# Access Compliance Report

## Public Rights-of-Way

Intersection ID: 5579	Main Street: FALLS_BRANCH_LN	Cross Street: GRAYS_CREEK_LN	Location: NE
ADA ID: 7690405F865F	Ramp Type: Perp	Initial Pass/Fail: Fail	Overall Compliance: No
Severity Score: 25			
Codes/Mitigation Info/Possible Solution		Field Measurements/Component Compliance

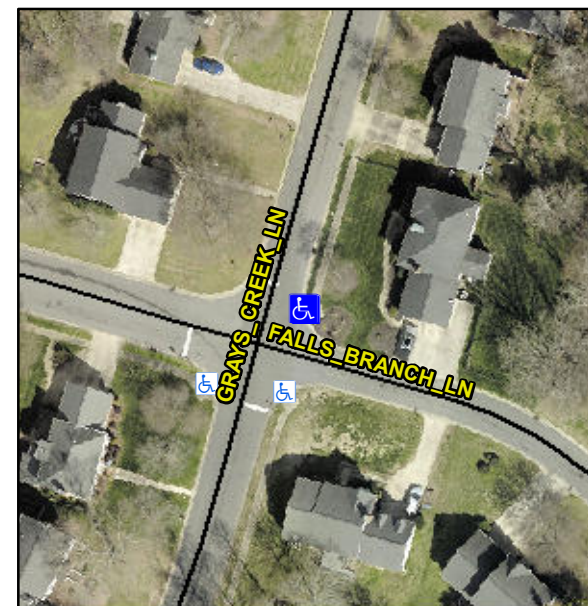
**Not Found, R304.5.3**

Compliance	Description	Data	Compliance	Description	Data
N/A	Ramp Length (in)	49.0	Yes	Ramp Slope (%)	6.5
Yes	Ramp Width (in)	48.0	No	Ramp XSlope (%)	9.1
N/A	Flare Type LT	N/A	N/A	Flare Type RT	N/A
N/A	Flare Slope LT (%)	N/A	N/A	Flare Slope RT (%)	N/A
N/A	Flare Traversable LT?	N/A	N/A	Flare Traversable RT?	N/A
N/A	Landing Length (in)	N/A	N/A	DWS Provided?	N/A
N/A	Landing Width (in)	N/A	N/A	DWS Contrast?	N/A
N/A	Landing Slope (%)	N/A	N/A	DWS Length (in)	N/A
N/A	Landing X Slope (%)	N/A	N/A	DWS Full Width?	N/A
N/A	Landing Curb? (Y/N)	N/A	N/A	DWS Offset (in)	N/A
N/A	Shared Landing?	N/A			
N/A	Gutter Ponding?	N/A	N/A	Gutter Slope (%)	N/A
N/A	Gutter Lip Ht (in)	N/A	N/A	Gutter X Slope (%)	N/A
N/A	Painted X Walk1?	No	N/A	Painted X Walk2?	N/A
	X Walk 1 Direction	To S		X Walk 2 Direction	N/A
N/A	X Walk 1 Width (in)	N/A	N/A	X Walk 2 Width (in)	N/A
	X Walk 1 Slope (%)	2.0		X Walk 2 Slope (%)	N/A
	X Walk 1 X Slope (%)	6.8		X Walk 2 X Slope (%)	N/A

**Remove & Replace Entire Ramp.**
